City of Port Phillip
Advertised Plan 1 of 40

28-32 ALBERT ROAD, SOUTH MELBOURNE
DRAWING LIST

AMENDMENTS TO ENDORSEMENT PLANS:

Project Title
28-32 ALBERT ROAD
SOUTH MELBOURNE

Drawing Title:
GENERAL ARRANGEMENT PLAN
BASEMENT 1 - BASEMENT 3

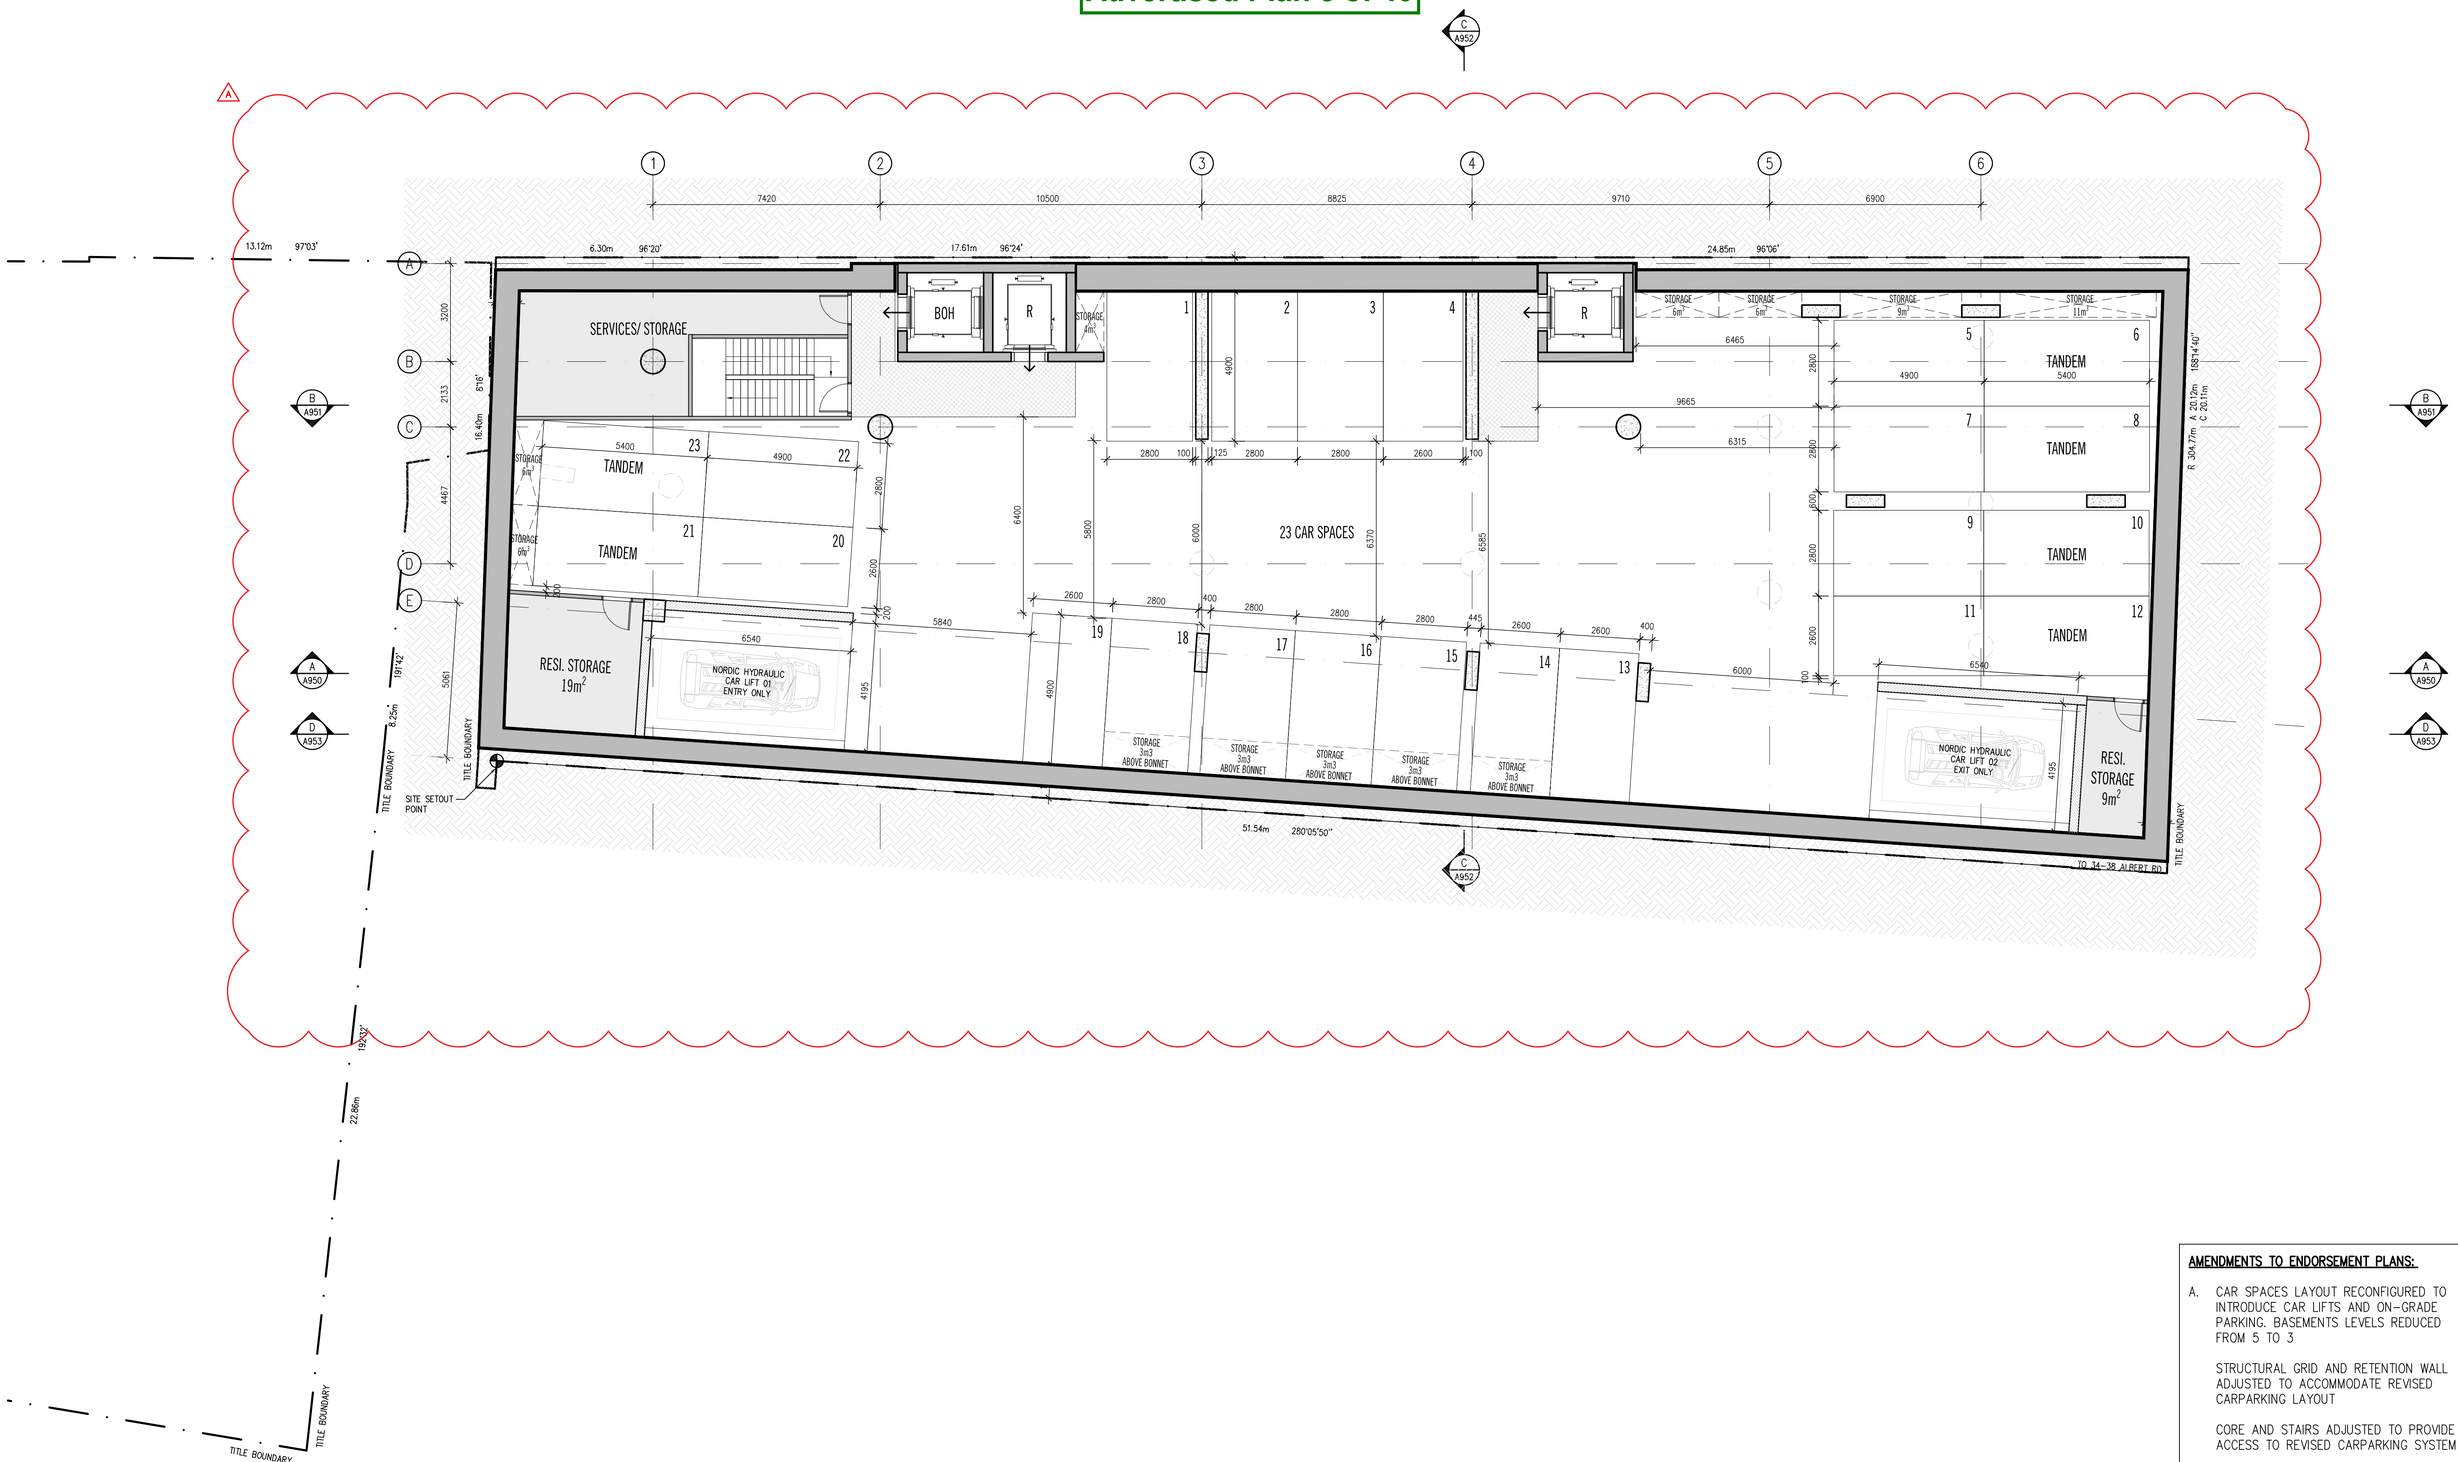
A. CAR SPACES LAYOUT RECONFIGURED TO INTRODUCE CAR LIFTS AND ON–GRADE PARKING. BASEMENTS LEVELS REDUCED FROM 5 TO 3

STRUCTURAL GRID AND RETENTION WALL ADJUSTED TO ACCOMMODATE REVISED CARPARKING LAYOUT

CORE AND STAIRS ADJUSTED TO PROVIDE ACCESS TO REVISED CARPARKING SYSTEM

Drawing Title
GENERAL ARRANGEMENT PLAN
LOWER GROUND

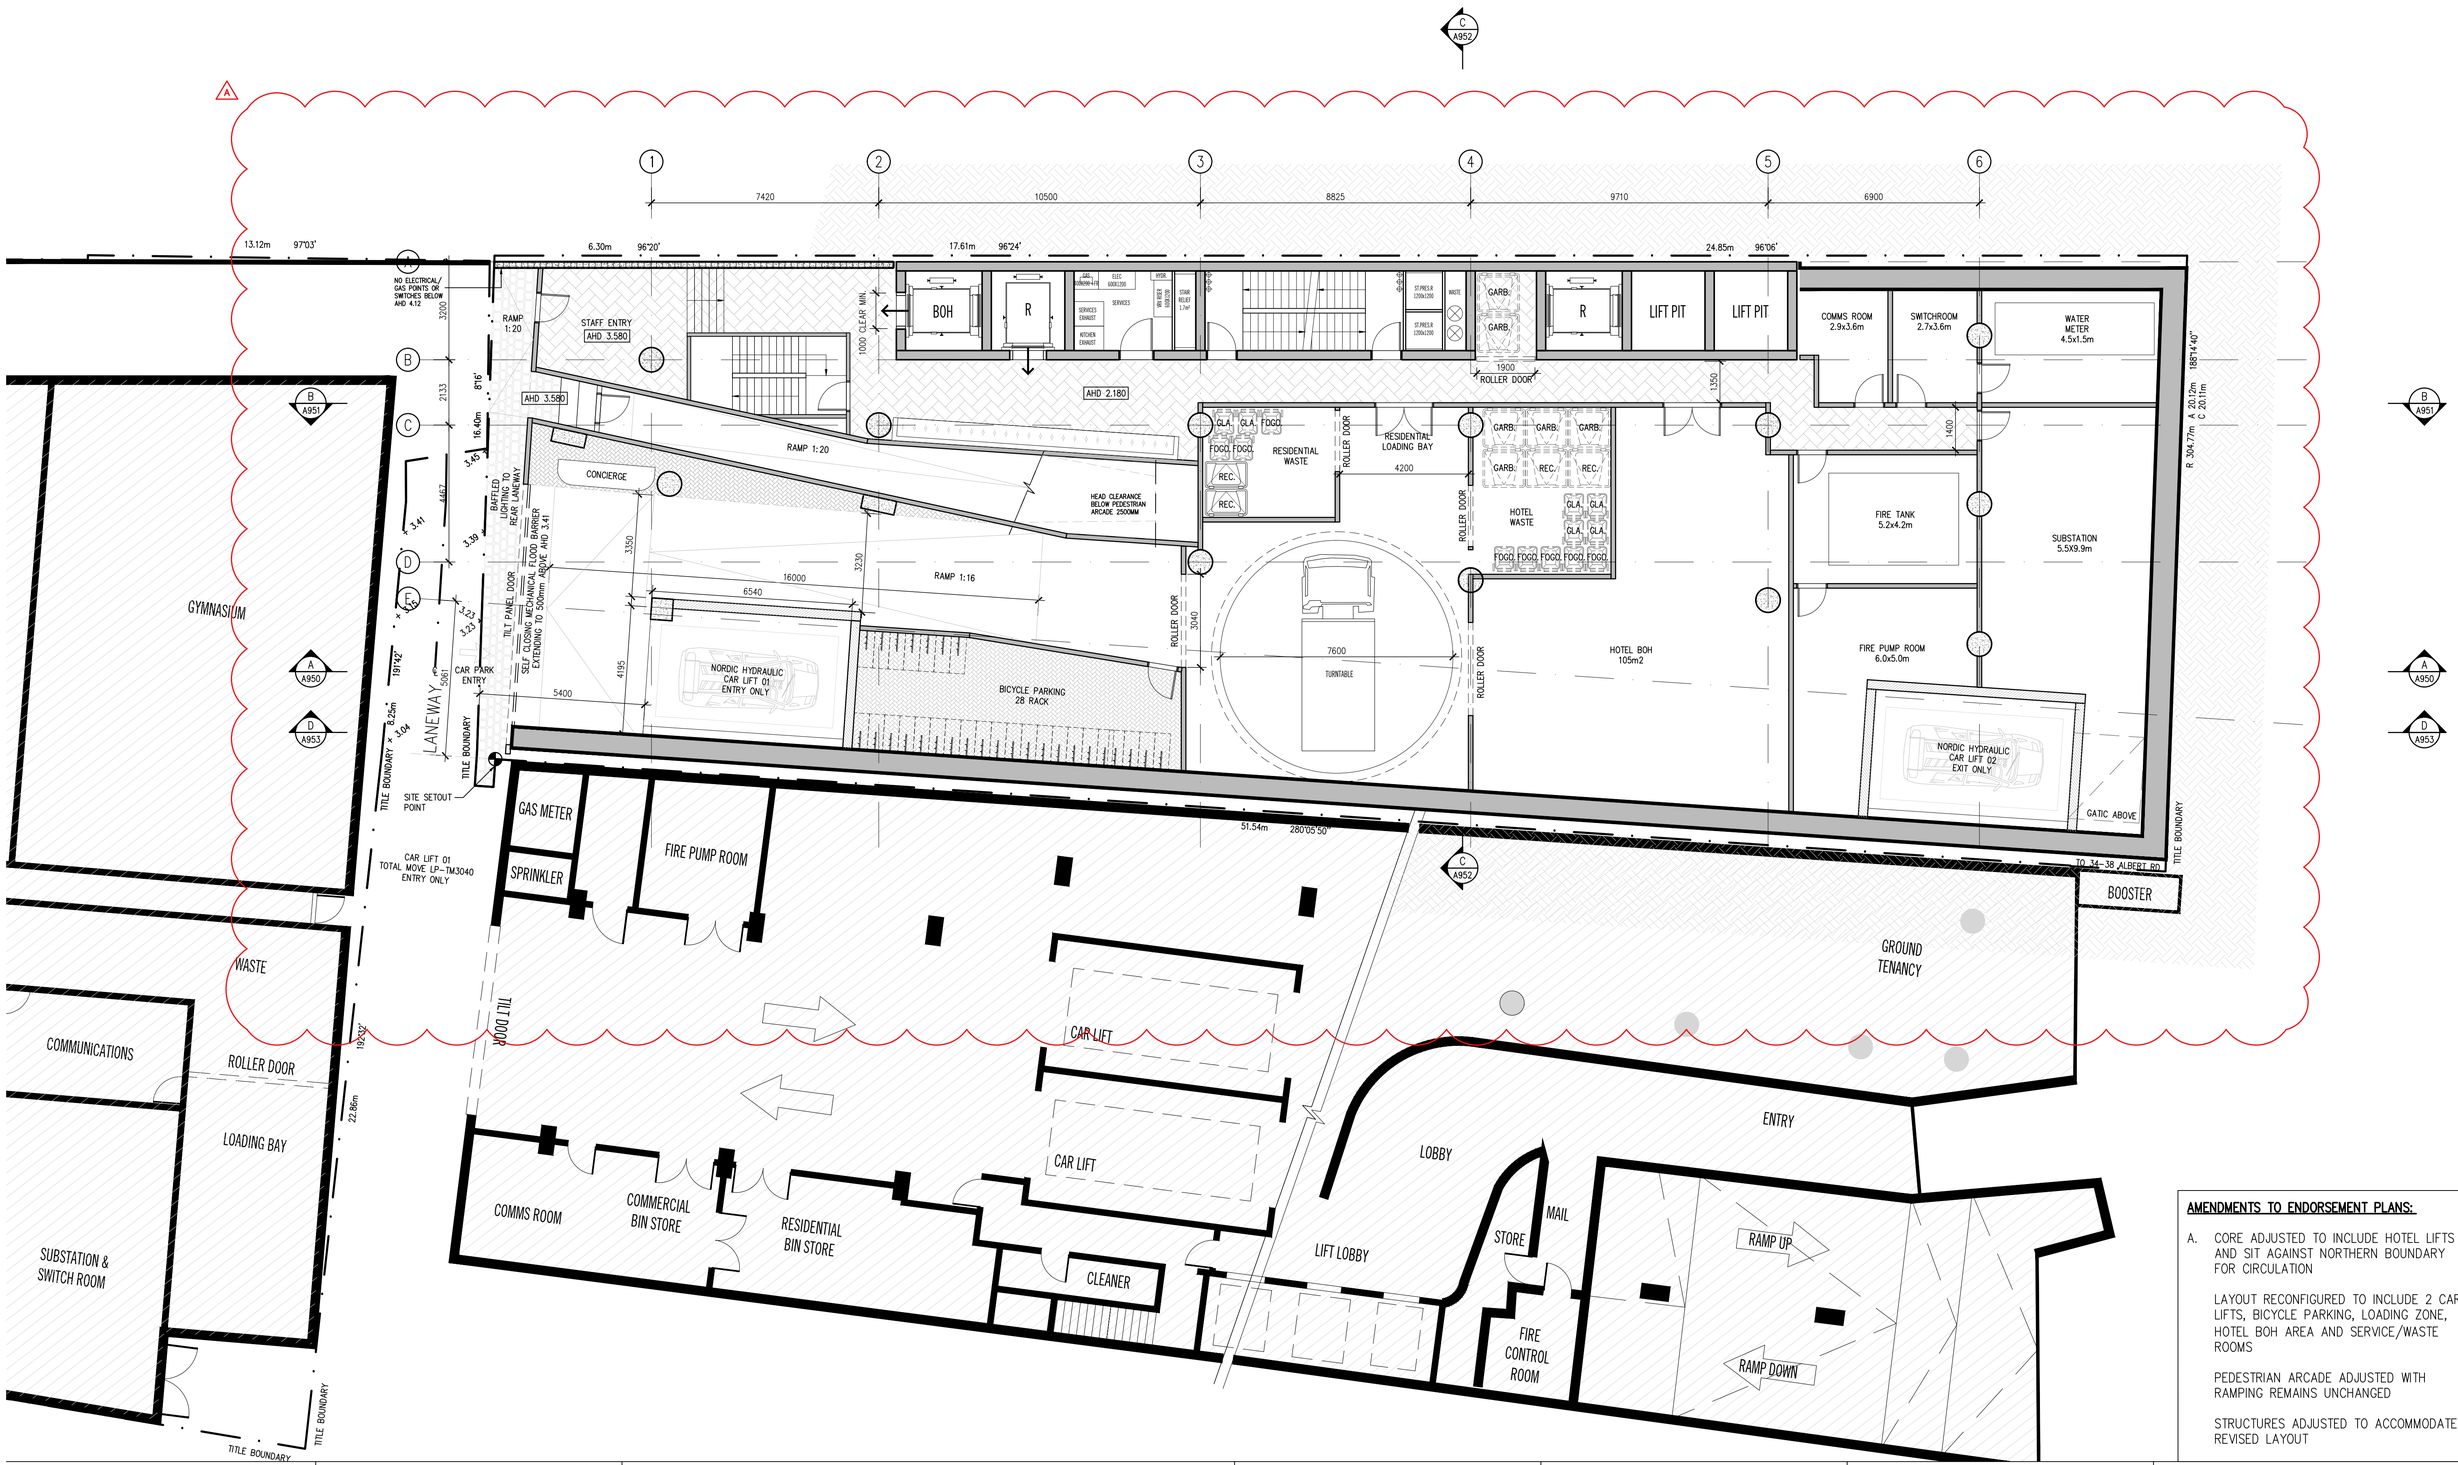
A. CORE ADJUSTED TO INCLUDE HOTEL LIFTS AND SIT AGAINST NORTHERN BOUNDARY FOR CIRCULATION

STRUCTURES ADJUSTED TO ACCOMMODATE REVISED LAYOUT

Drawing Title
GENERAL ARRANGEMENT PLAN
GROUND FLOOR

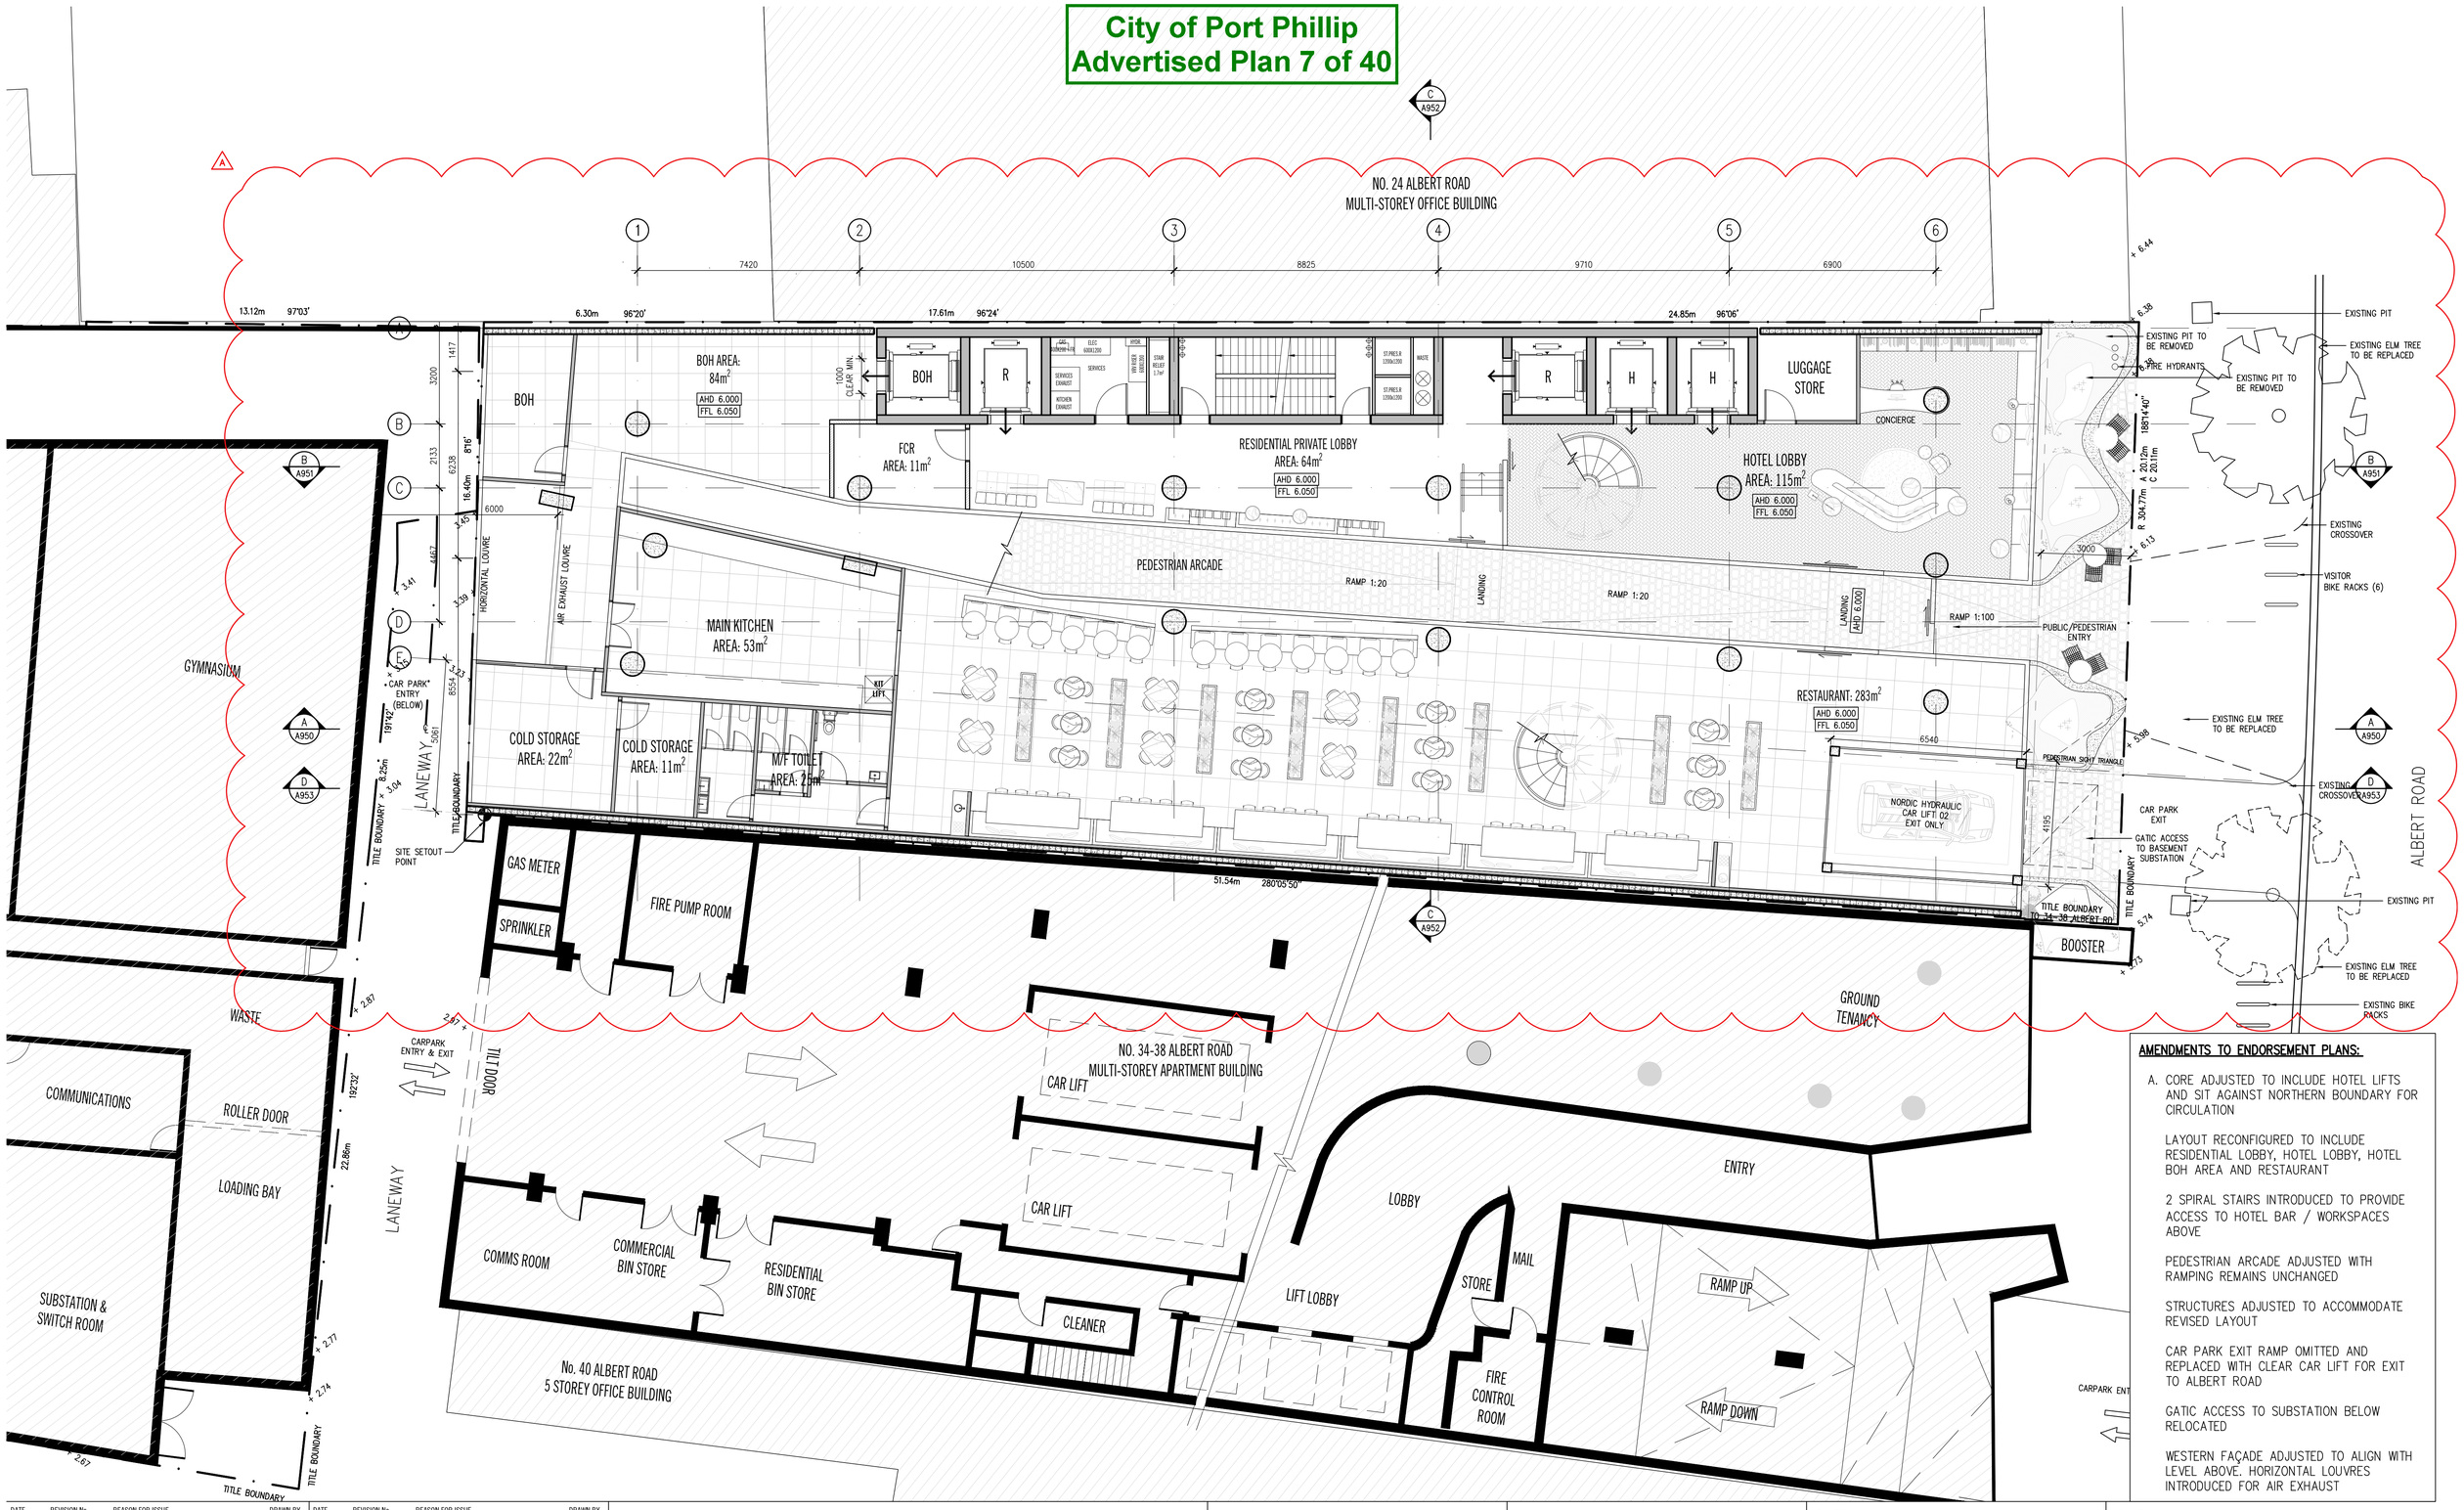
A. CORE ADJUSTED TO INCLUDE HOTEL LIFTS AND SIT AGAINST NORTHERN BOUNDARY FOR CIRCULATION

2 SPIRAL STAIRS INTRODUCED TO PROVIDE ACCESS TO HOTEL BAR / WORKSPACES ABOVE

STRUCTURES ADJUSTED TO ACCOMMODATE REVISED LAYOUT
